Re: VARIANCE REQUEST
NUMBER 5 MARYLAND AVE LLC
1724 WESTMORELAND TRAIL
ANNAPOLIS, MD 21401

VARIANCE PLAN FOR 1724 WESTMORELAND TRL

VARIANCE SITE PLAN

OFFICE OF PLANNING AND ZONING

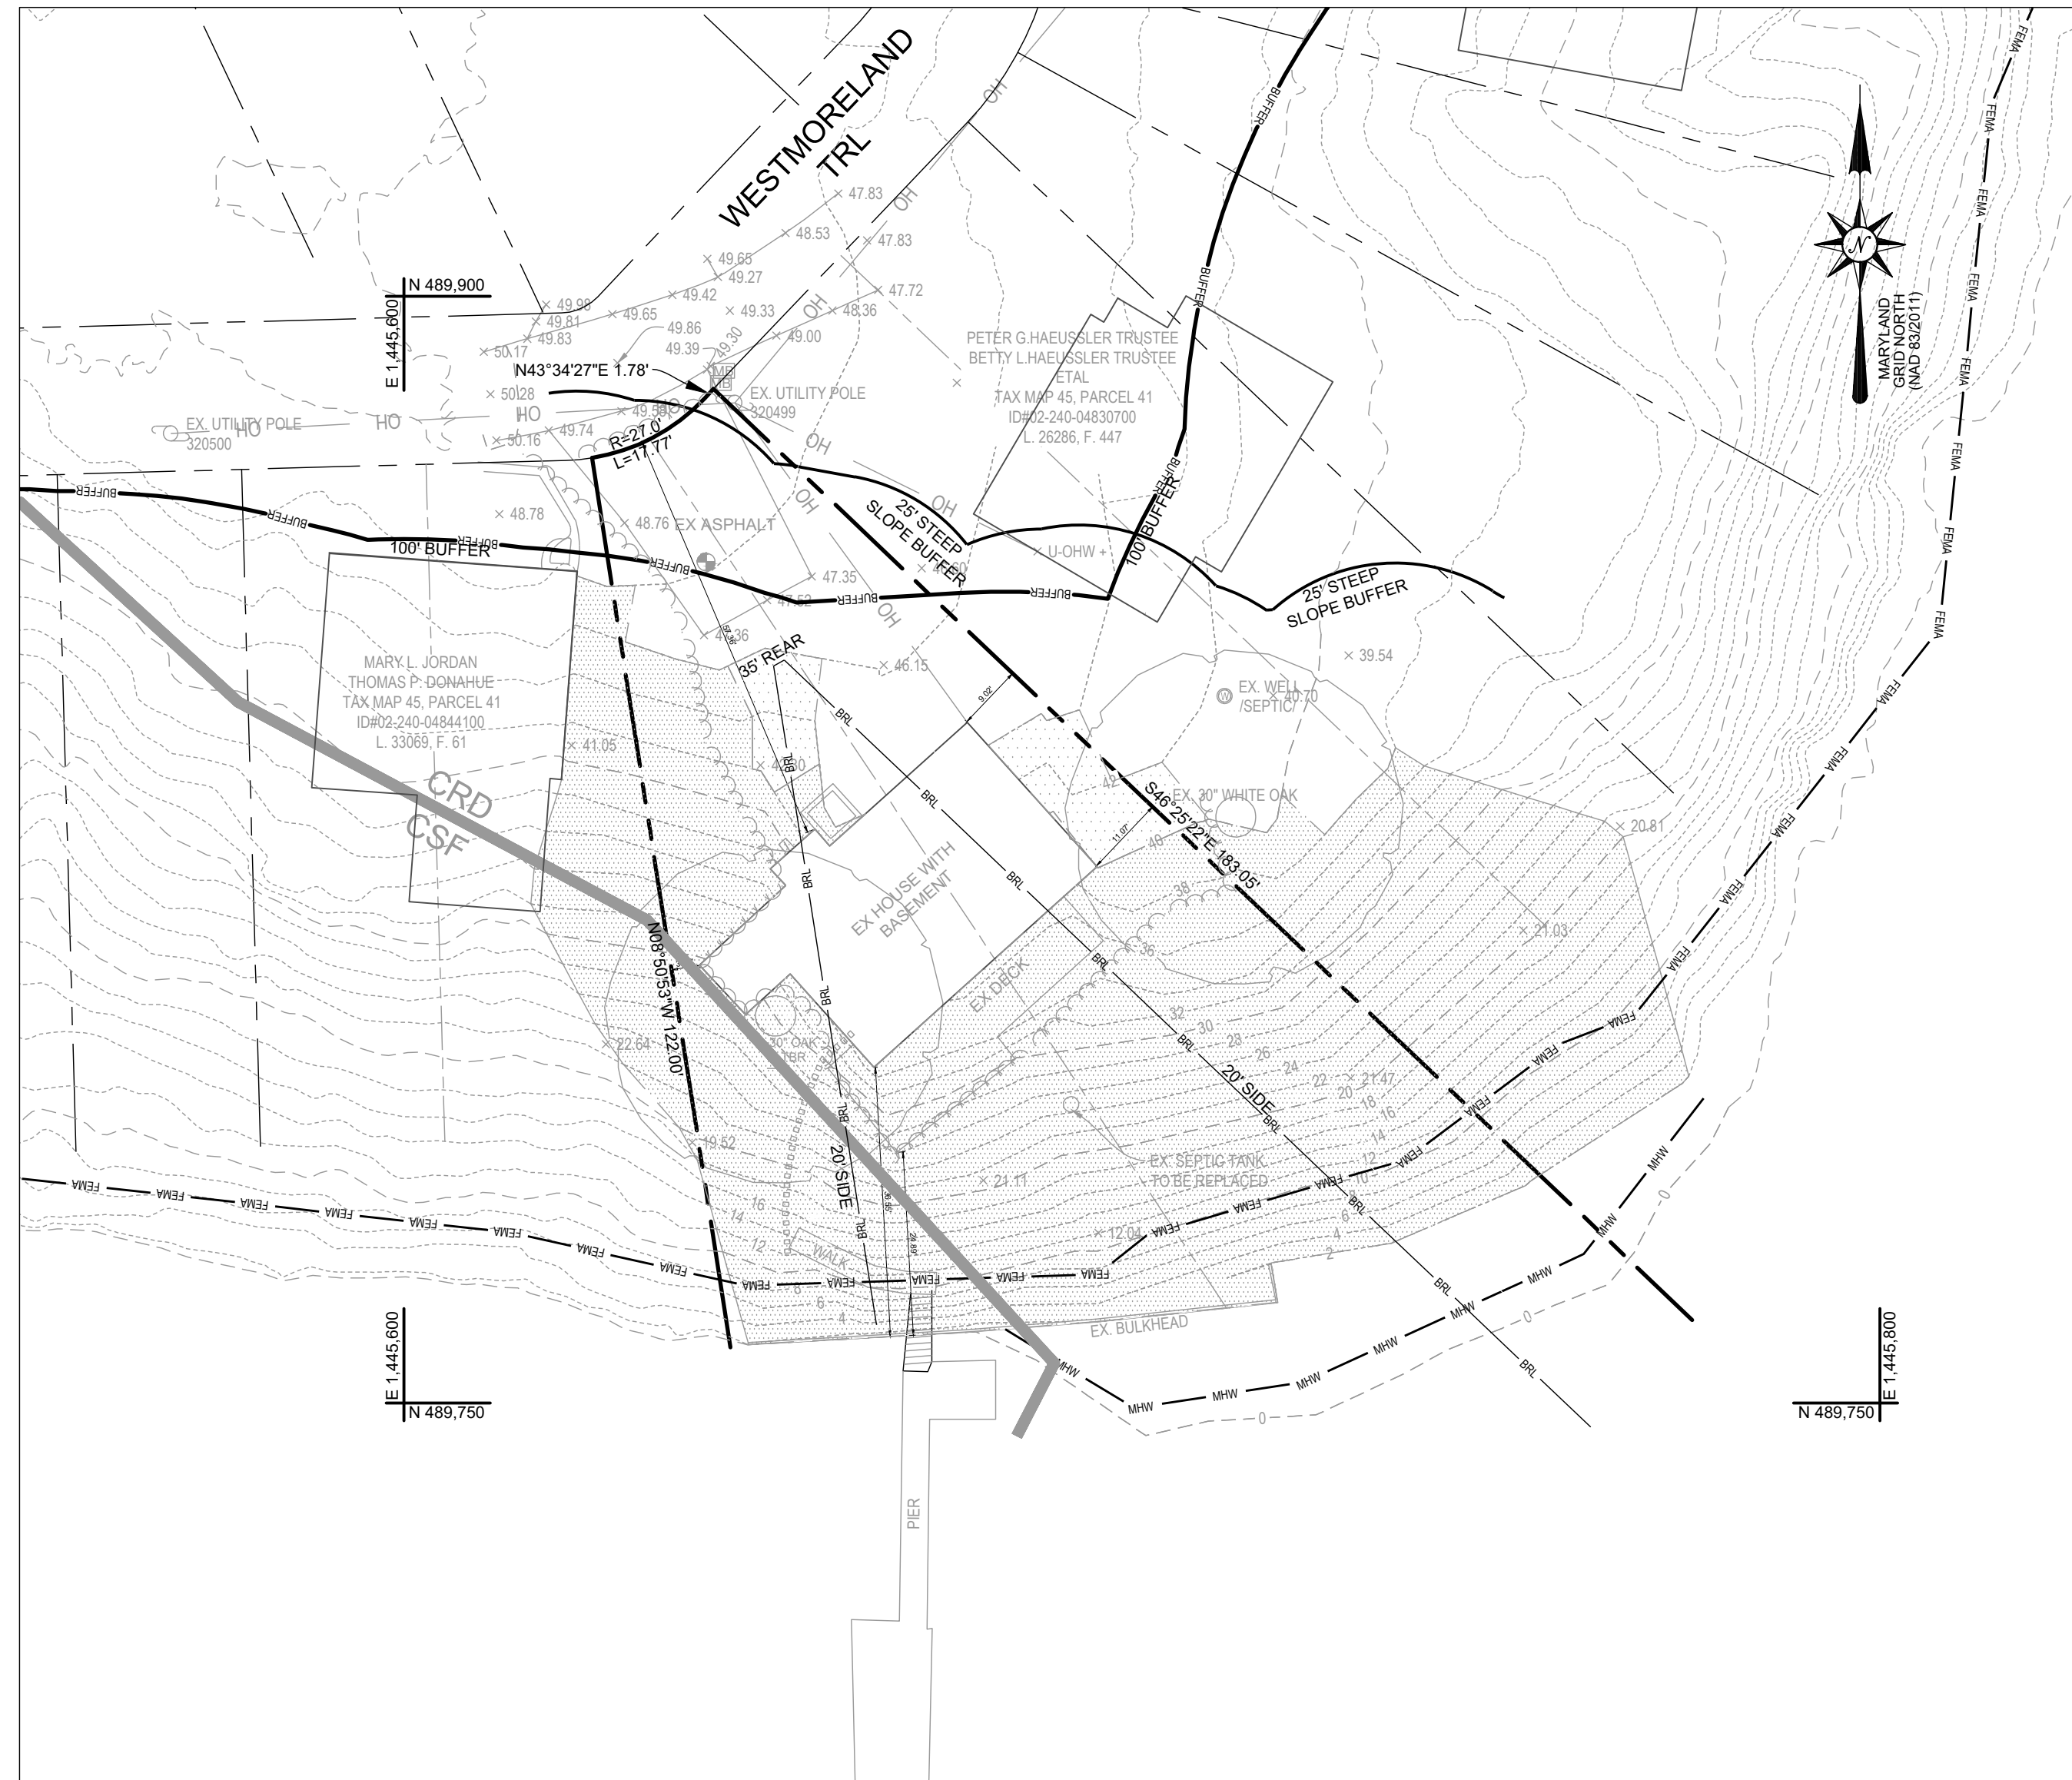
Engineering advised that no SWM ESD practices may be located in any environmentally sensitive areas or their buffers. If indeed the site is buffer and not modified, no SWM practices may be in the 100 buffer. The entire site is steep slope and buffer. shaded as 25% slopes, therefore there is no area to provide SWM.

Critical Area Team advised Per correspondence with the Health Department, although recommendations were made in May 2021, a site plan for the addition has not been submitted and the application is still pending. Every effort should be made to locate/design the system to minimize disturbance to the onsite slopes including locating the system on the roadside if possible. Expansion of the footprint or decks that results in additional permanent slope disturbance will not be supported. The LOD that will be established for temporary disturbance during demolition is not intended to open that area for, construction/grading.

Zoning requests house and deck dimensions be labeled, also indicate number of stories. New dwelling offers opportunity to comply with side lot line setbacks. Need to justify. Please provide floor plan if possible.

Pre file comments noted concern about stormwater management. It should be noted that the proposal includes a cistern for the front of the house, which while being in the buffer it very close to the buffer line, and not located on steep slopes. Rain handlers or similar will be utilized for the waterfront side of the dwelling. This site is reducing lot coverage and replacing an existing dwelling in the same footprint. This fact alone will reduce stormwater impacts, however the cistern provides stormwater management to the extent practicable. The plan is being sent to the Health Department for their review.

The stormwater management shown is a concept. It is our understanding that I&P is reviewing how stormwater management is treated on sites such as this, which are extremely encumbered by steep slopes and their buffer.
